POWER PLANT – ENGINE – EEC HARNESS – FAN AND EEC HARNESS – CORE – INTRODUCTION OF
ADDITIONAL SUPPORT FOR ELECTRICAL CONNECTORS – CATEGORY CODE 4 – MOD.ENG-71-0063

V2500-ENG-71-0063

View showing support for electrical connectors
Fig.1

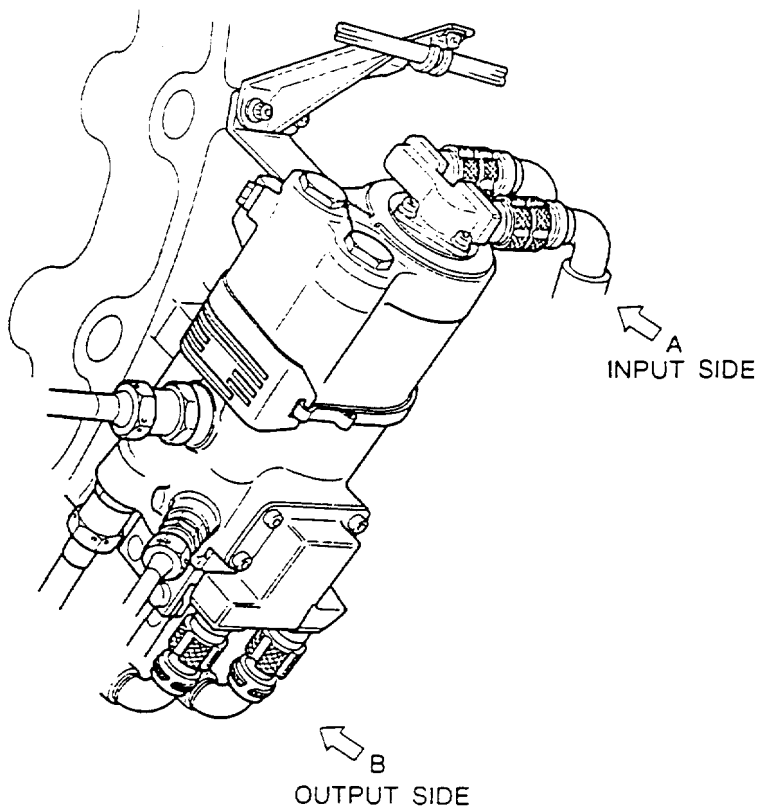
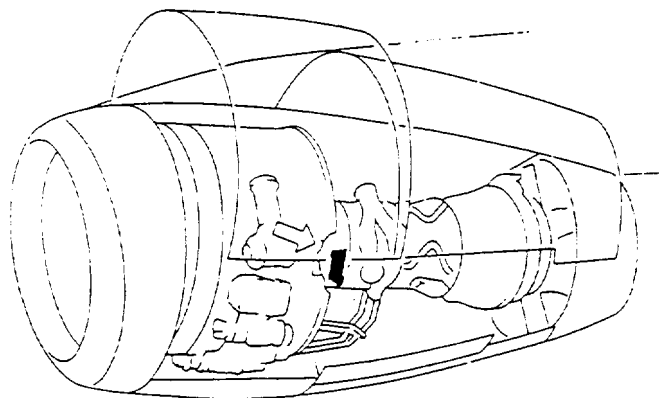
- (a) Two EEC harness-fan connectors connected to the EDA are retained together with added two JM44LC39H109RG Clips, two 5W1086 Washers, 4W0104 Bolt and 4W0001 Nut.
- (b) Two harness-core connectors connected to the input side of VSVA are retained together with added 5W2166 Bracket, two JM44LC39H110RG Clips, two 4W0107 Bolts, four 4W2621 Washers and two 4W0001 Nuts.
- (c) Two EEC harness-core connectors connected to the side of VSVA are retained together with added two JM44LC39H106RG Clips, 4W0107 Bolt, two 5W1086 Washers and 4W0001 Nut.

- (1) Retain the two fan harness connectors connected to the EDA.
 - (a) Install JM44LC39H109RG Clip to each connector backshell. Retain installed two clips together with 4W0104 Bolt, two 5W1086 Washers and 4W0001 Nut.

- (b) Torque the nut to 36 to 46 lbfin (4 to 5 Nm).
- (2) Retain the two core harness connectors connected to the input side of the VSVA.
 - (a) Install JM44LC39H110RG Clip to each connector backshell. Retain each installed clip to the 5W2166 Bracket with 4W0107 Bolt, two 4W2621 Washers and 4W0001 Nut.

View of the variable stator vane actuator - Before alteration
Fig.2

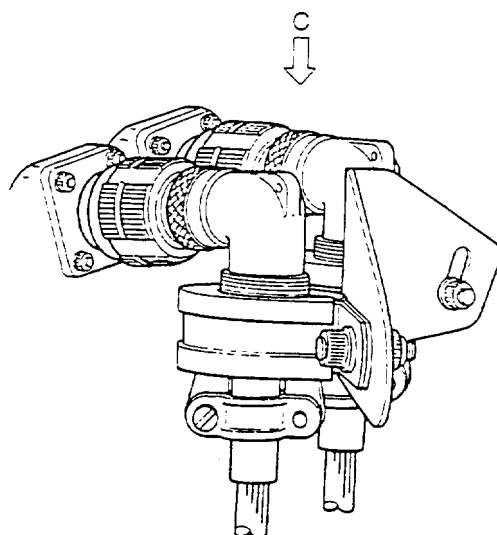
Pins and sockets of electrical connectors at the variable stator vane actuator (VSVA) and the engine dedicated alternator (EDA) have a possible fretting caused by vibration.

Electrical connectors used at the VSA and the EDA have a small backlash of coupling ring latch mechanism under the fully engaged condition. Engine vibration and this backlash may vibrate the plug against the receptacle. Therefore fretting may occur between the pin and socket. Clipping of adjacent two connectors has been provided to prevent vibration of the plug.

View showing support for electrical connectors
Fig.3

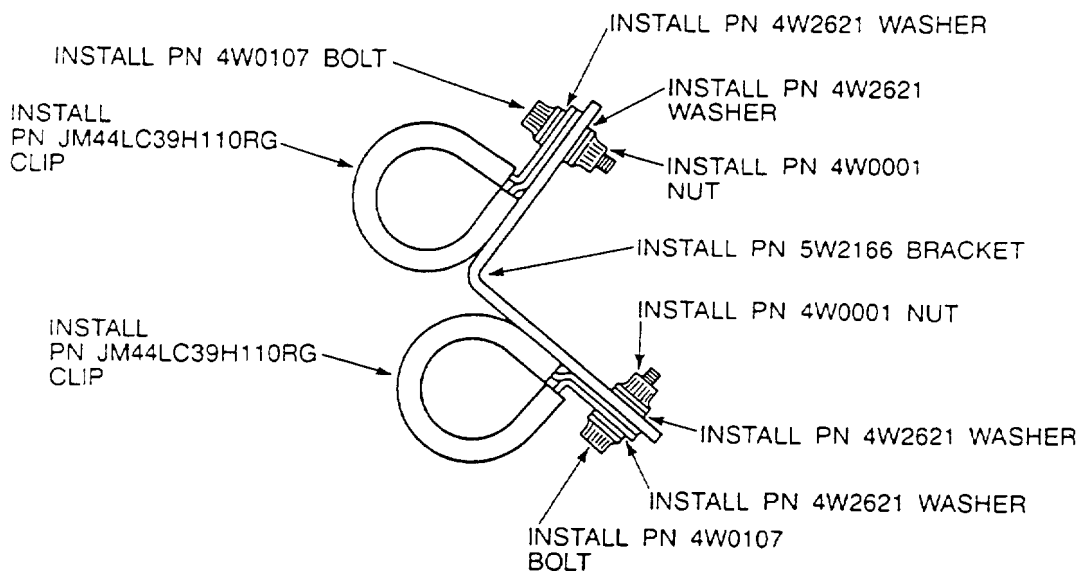
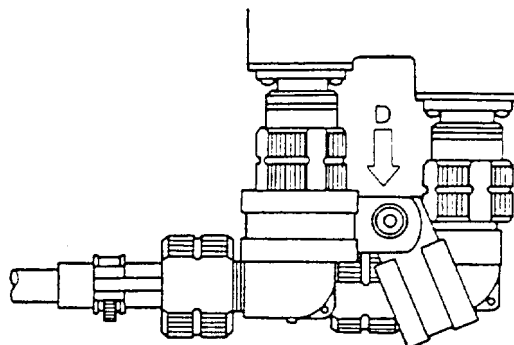
- (b) Torque the nuts to 36 to 45 lbfin (4 to 5 Nm).
 - (c) Safety the bracket to the one of two connector backshells using CoMat 02-146 locking wire. Use locking wire hole of the bracket and one of locking wire hole on the backshell relief clamps.

View showing support for electrical connectors
Fig.4

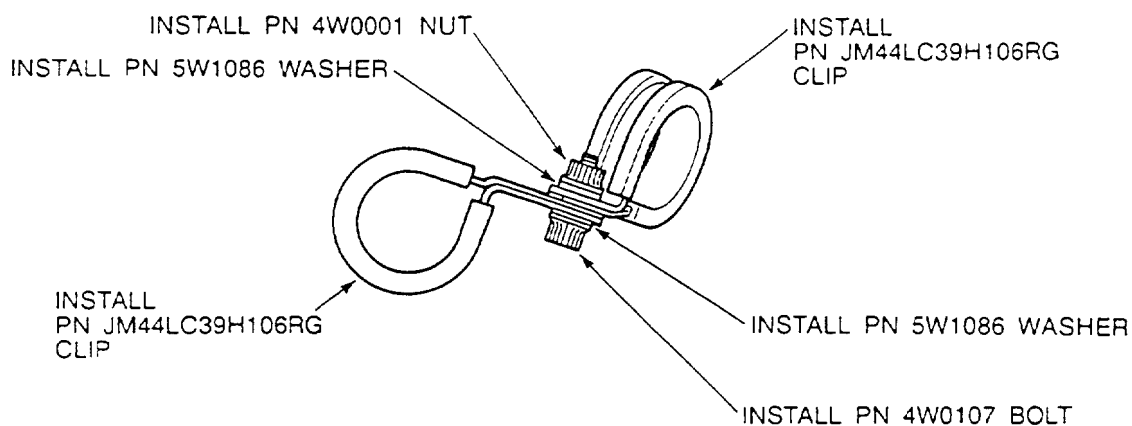
- (3) Retain the two core harness connectors connected to the output side of the VSVA.
 - (a) Install JM44LC39H106RG Clip to each connector backshell. Retain installed two clips together with 4W0107 Bolt, two 5W1086 Washers and 4W0001 Nut.

- (b) Torque the nut to 36 to 45 lbfin (4 to 5 Nm).
